## **TECHNICAL NEWS**

## Brush motor Fuse My50

Machine model:	My50
Subject:	Brush motor Fuse
Since the serial number:	213002974
Modification date:	18.03.2013
TM Reference:	355

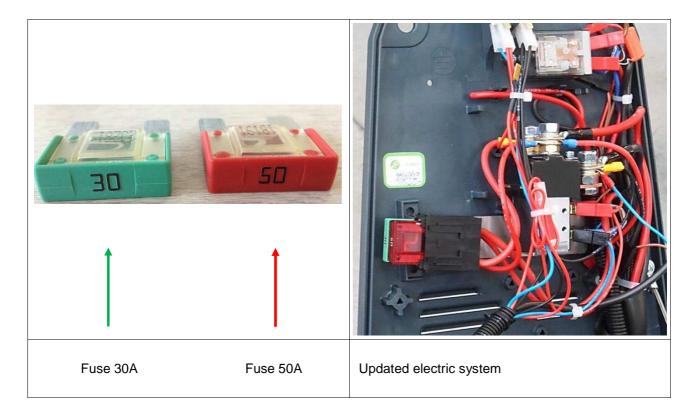
In order to prevent the premature action of the fuse in the start-up transients of the motor brush in case the machine is used with buffer, the 30A fuse has been replaced by a 50A one.

This avoids the intervention of the fuse even for start-up transients in excess of those at standard conditions

INCITIOVEG		
Code	Quantity	Description
409607	1	MAXIFUSE 30A
Added		
Code	Quantity	Description
409612	1	MAXIFUSE 50A

Note: The new fuse can be installed on previous models as well
